PLANNING COMMISSION

To: Clint Osiek
From: Hooper City Staff
CC: Mayor Fowers, Jared Hancock, Tracy Allen
Date: December 2, 2020
Re: Osiek Subdivision – Final Plat Review

To: Ashlee Wheeler
From: Hooper City Staff
CC: Mayor Fowers, Jared Hancock, Tracy Allen
Date: November 20, 2020
Re: Wheeler Subdivision Final Plat Review

To: Hooper City Planning Commission
From: Jared Hancock - Hooper City Public Works Director
Date: December 2, 2020
Subj: Silver Saddle – Drainage Plan Change

OSIEK SUBDIVISION

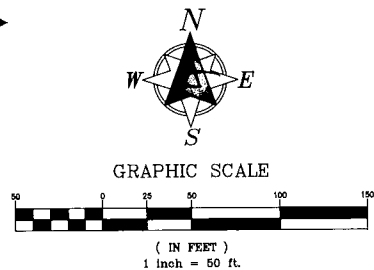
1. It appears from the documents submitted in addition to the plat that the intent of the subdivision is to create a one-lot subdivision and to develop the larger parcel at a later date (no additional approved building lot at this time). Lot 2 should be renamed as "Remainder Parcel – Not Approved for Development." **This has been updated. OK**

3. The overall subdivision boundary does not close to within acceptable tolerance (closure error = 0.11'). Please clarify. **OK**
4. Lot 1 closes and shows the correct area. **OK**

5. The remainder parcel does not close to within acceptable tolerance (closure error = 0.09'). Please clarify. **OK**

6. Lot 1 conforms to the lot size and frontage requirements of the R1 zone. OK
7. Please check the tie to the section corner. it does not match the “John & Julie Naisbitt Subdivision” that is on the west side of 6700 West. **This has been corrected on the plat map with the dimension of 322.24’. However, the Legal Description shows a dimension of 272.24’. It also states that the subdivision has 2 lots. Please clarify.**

8. Please contact the City’s contract surveyor, David Strong, at J-U-B Engineers (801-547-0393) to discuss the right-of-way line for 5500 South. **This contact occurred. However, it does not appear as though the instructions provided by the city surveyor were incorporated. The instructions were to establish the right-of-way by using the centerline data from Record of Survey #1833 for both 5500 South and 6700 West. Please clarify.**

9. A 10-foot PUE is required along all street frontages. **OK**
10. A Vicinity Map is required on all Hooper City Plats. **OK**
11. The Owners Dedication must refer to “Hooper City” in the text. **The City’s name has been included in the Owner’s Dedication. However, the text still refers to a subdivision of 2 lots. This needs to be corrected.**

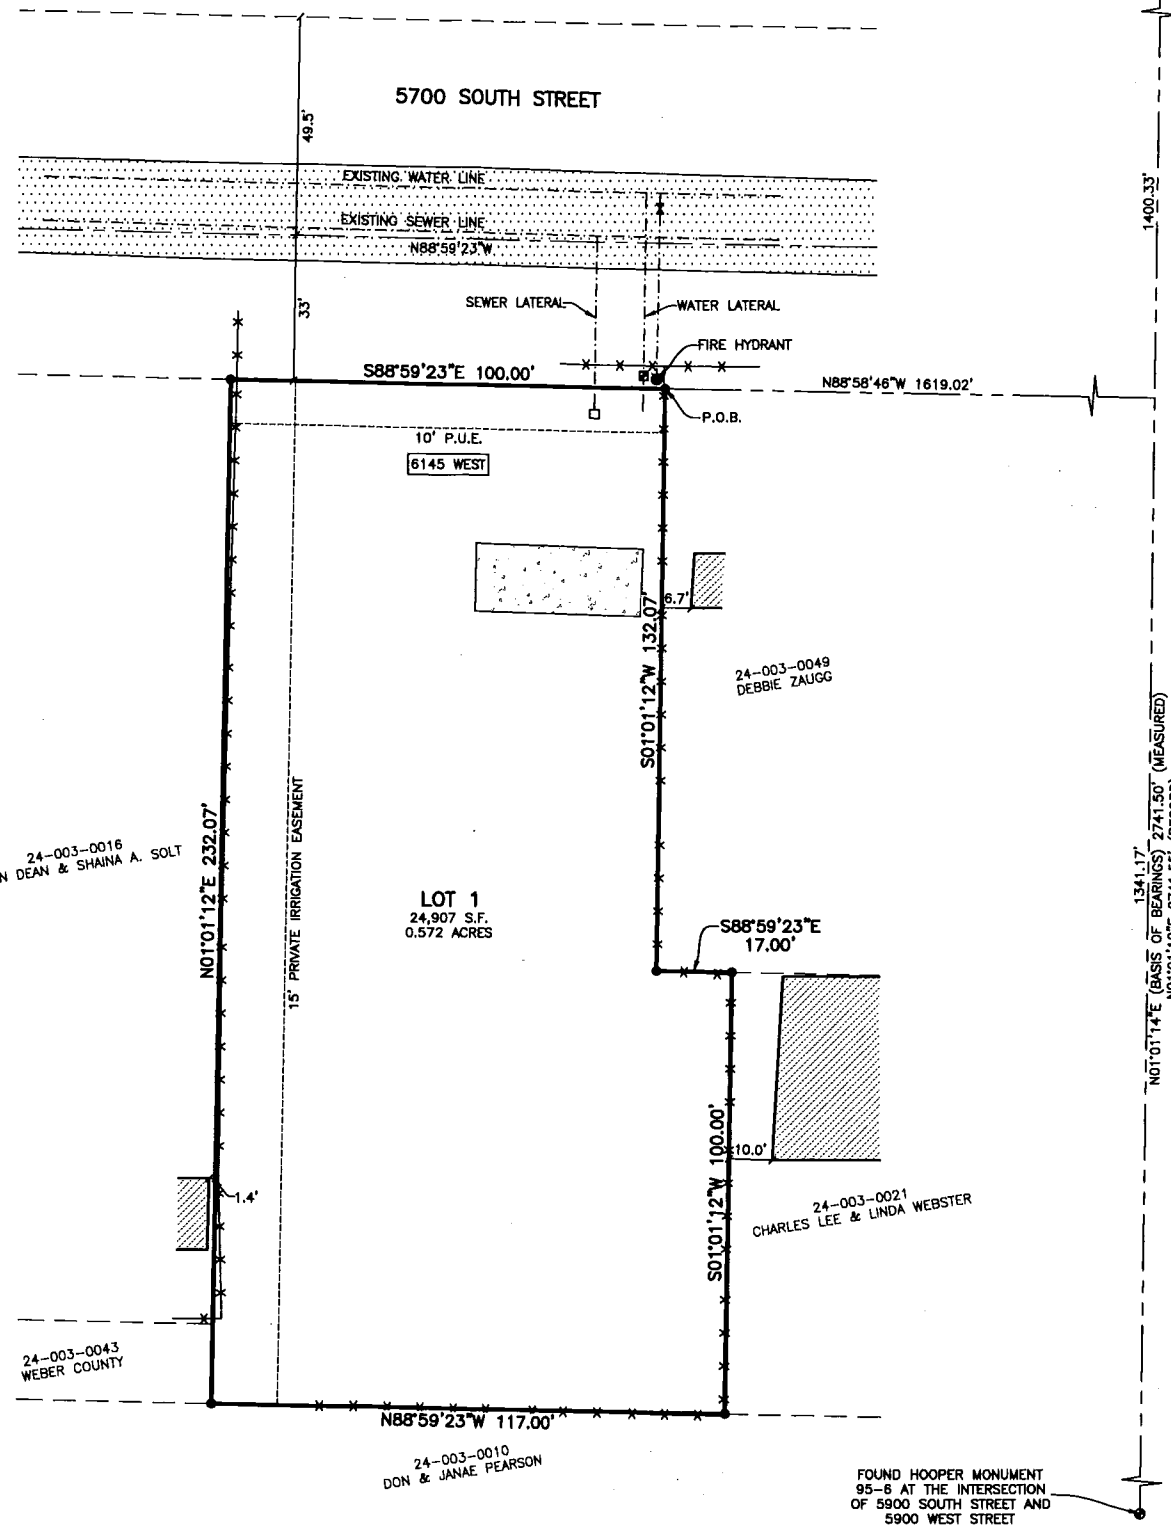
1. The lot conform to the lot size and frontage requirements of the R2 zone. **OK**
2. The subdivision boundary closes and the plat map boundary matches the written boundary description. **OK**

3. The Owners Dedication must refer to Hooper City. **OK**
4. The signature block for Taylor West Weber Water Improvement District needs to be changed to Hooper Water Improvement District. **OK**

5. The address for Lot 1 to be added to the plat will be 6145 West. **OK**
6. City ordinances state that no basements (lowest floor slab lower than exiting adjacent grade) are allowed if a public land drain system isn't available to connect a footing drain into with a gravity land drain lateral. A note must be added to the plat stating that no basement will be permitted on Lot 1. **OK**

New Note: Please label the 15' Drainage Easement shown on the plat as "15' Private Irrigation Easement." OK

New Note: Note 6 on the improvement plan should refer to Hooper Water standards and not City standards. OK

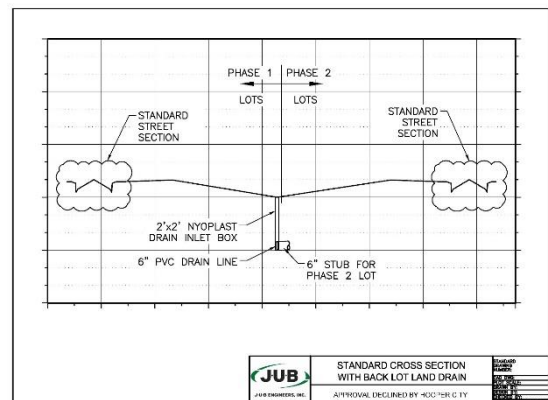
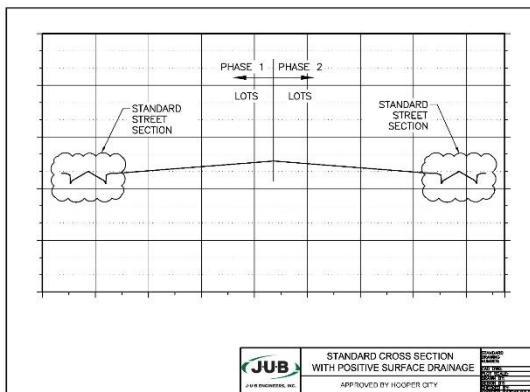
“The yard drain system added to the back of lots 11 thru 18 is not acceptable. Public Works has reiterated several times that this is not a solution to proper lot grading. It was reluctantly accepted on the west side of the subdivision adjacent to property that is not in the subdivision. It is not an acceptable solution between lots that haven’t yet been developed. The previous grading plan showed a slight ridge along the rear lot lines between the two phases of the subdivision. That is the grading plan that is acceptable to Public Works.

3. The proposed system gives cause for several concerns:
 - A. The plan includes piping that size wise typically serves a residence, not an entire neighborhood. The Storm Drain in the street collects less area and is much larger than the proposed pipe that collects the entire lots drainage of both phase 1 and phase 2.

- C. The drain collection boxes do not meet city standard, are plastic and will likely be destroyed during construction.
- D. The connection to the city's storm drain system has not been approved. There may be storm water pollution issues in the rear lot system that create storm water issues for the city's MS4 Permit and SWPPP. The storm drain system may surcharge the rear lot drainage system under normal operating parameters and actually add water to the yards, not drain them under flood conditions when they are needed most.

- E. Changing the plan to allow rear lot drainage will only benefit the developer, the homeowners that will live there and the city will deal with the results forever. There will never be a better or cheaper time to get the grading correct than during the initial development, prior to homes, fences, landscaping, private grading, and issues.

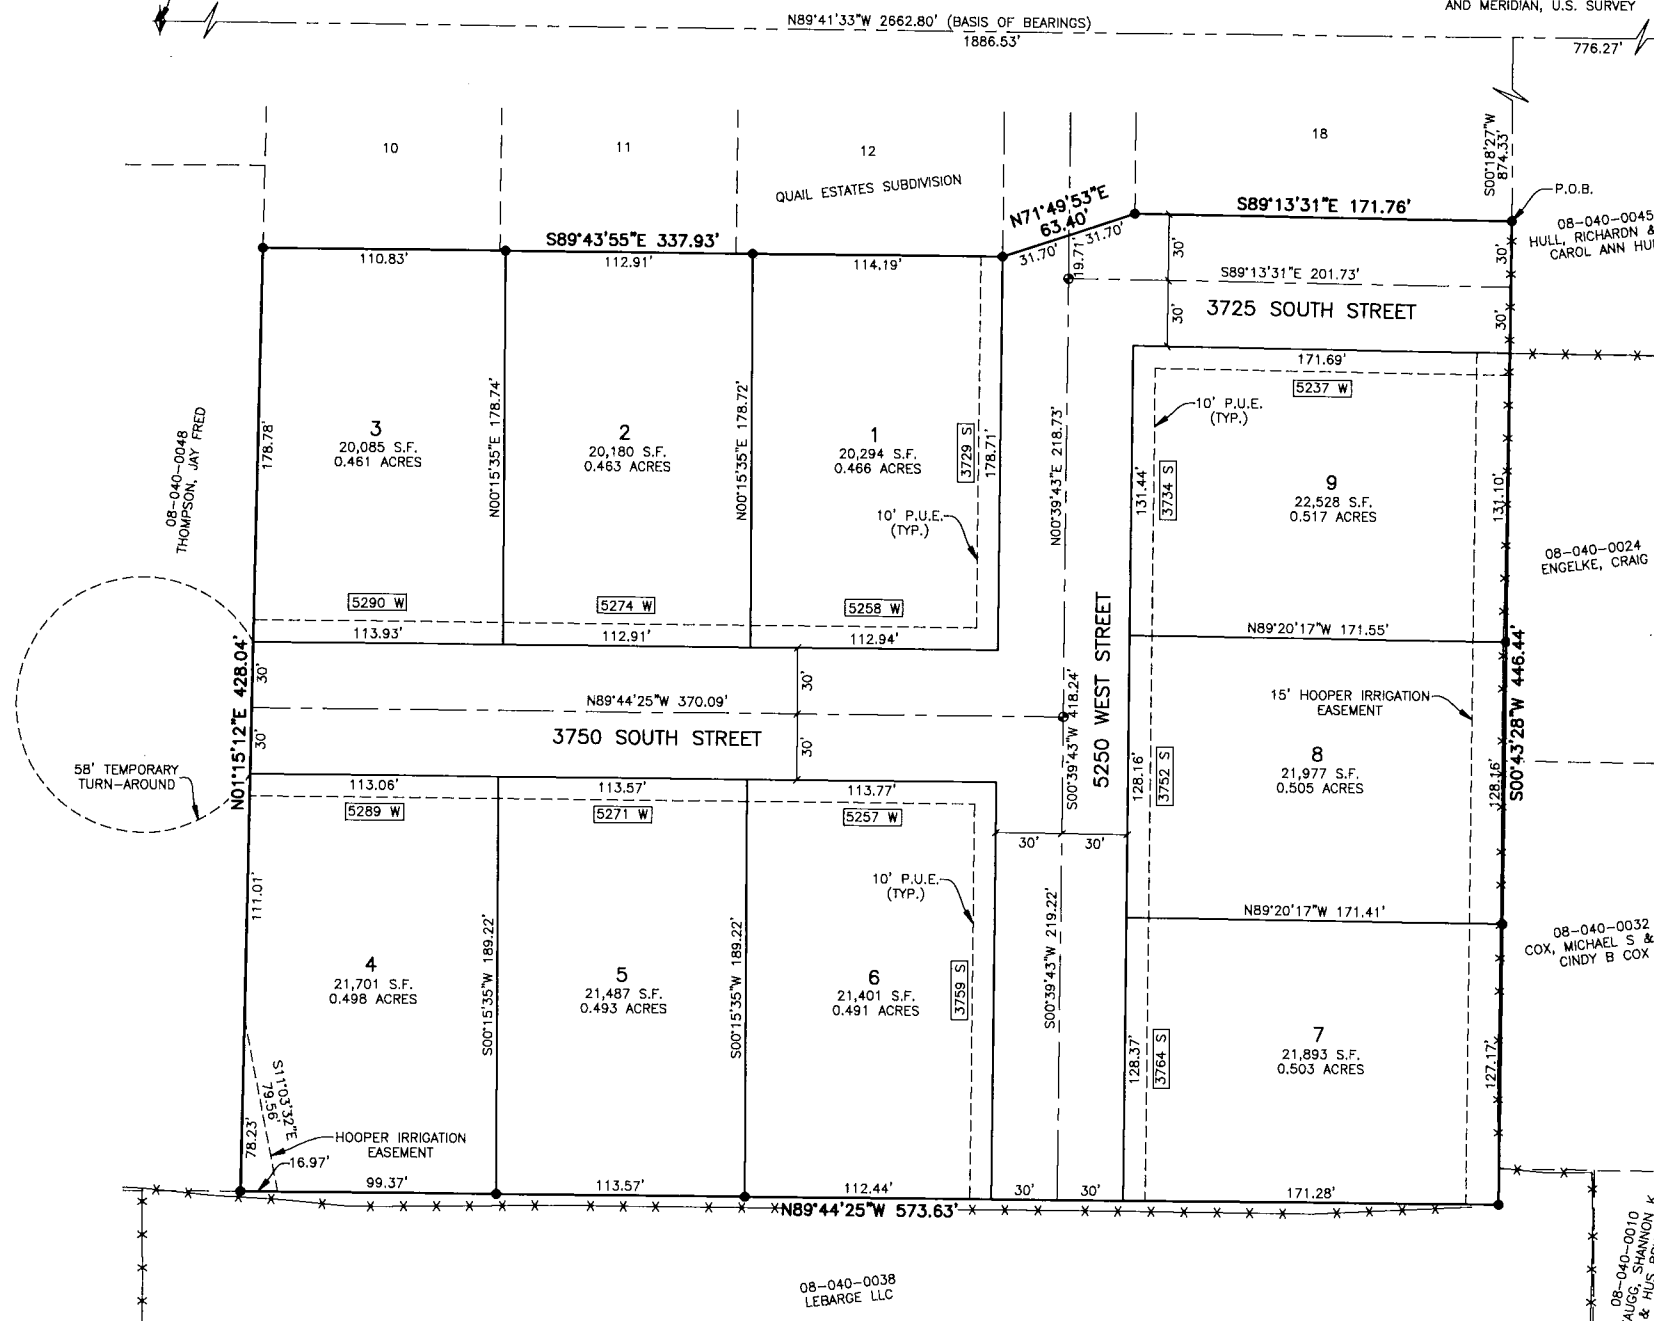
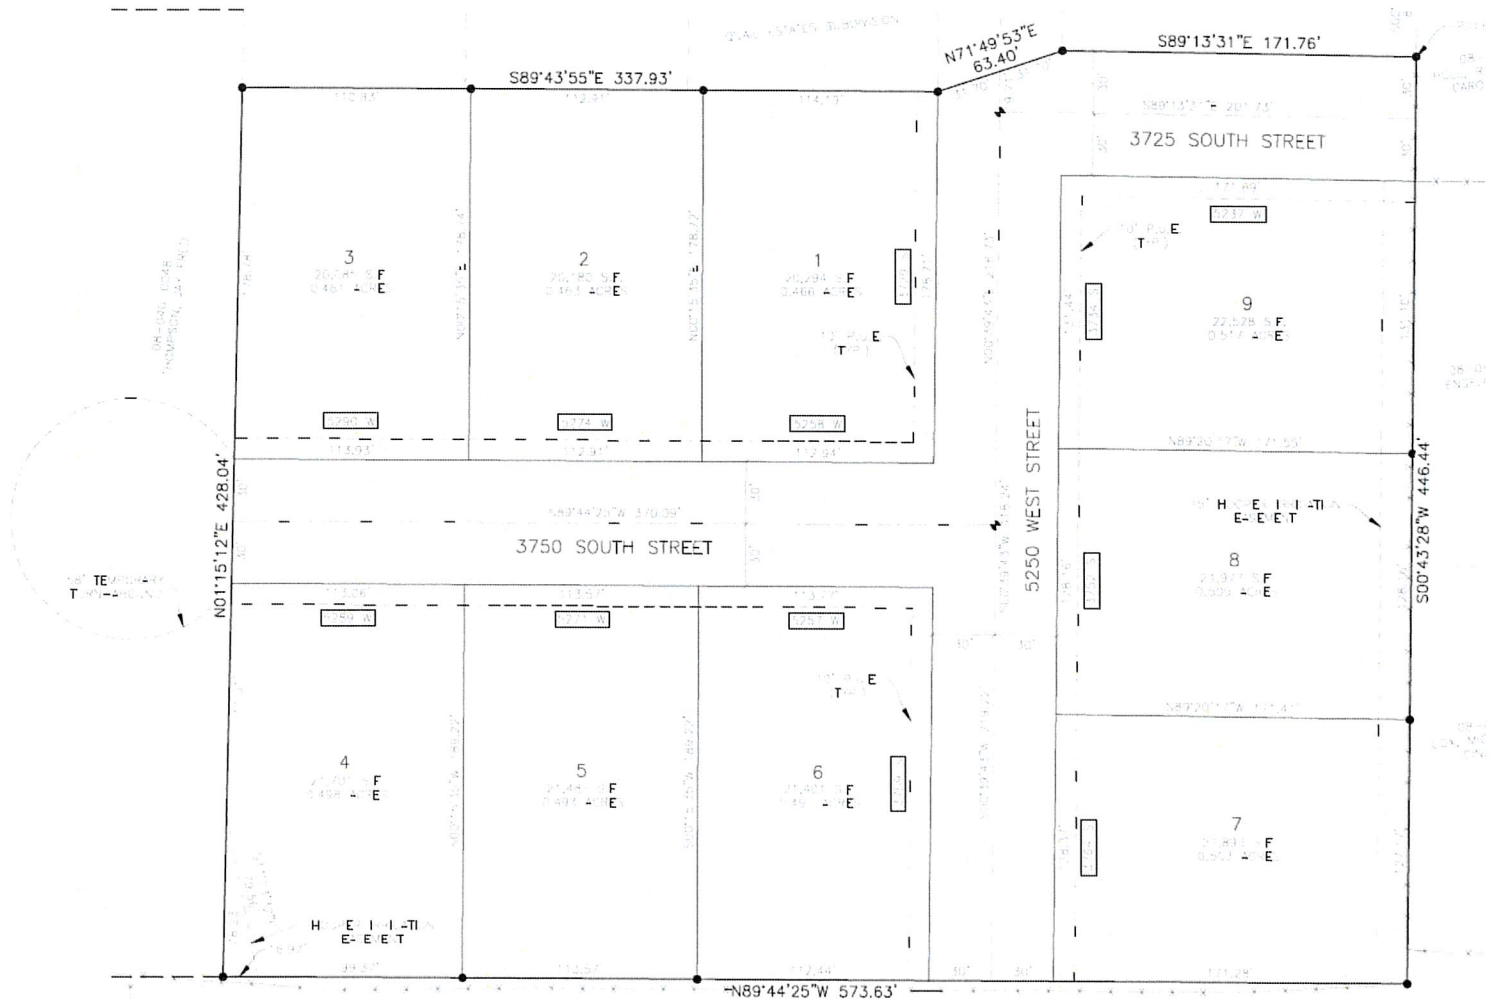
The City Staff has reviewed the updated improvement plans submitted to the City office showing the revised location of the temporary turn-around at the end of 3750 South Street. It is the staff's understanding that the developer would like to present this change of the previously approved plat and plans to the Planning Commission and City Council for approval. The staff supports this proposed change and has the following comments:

1. The staff was unable to locate a revised plat as part of the submittal. The revised final plat is needed in order for the relocation of the temporary turn-around to be approved.
2. It appears as though the property onto which the turn-around is proposed to be moved is not currently owned by the Quail Cove developer. Before the Planning Commission can recommend approval of the change, either the property will be in the developer's name or a signed agreement from the existing property must be provided indicating acceptance of the proposed change.
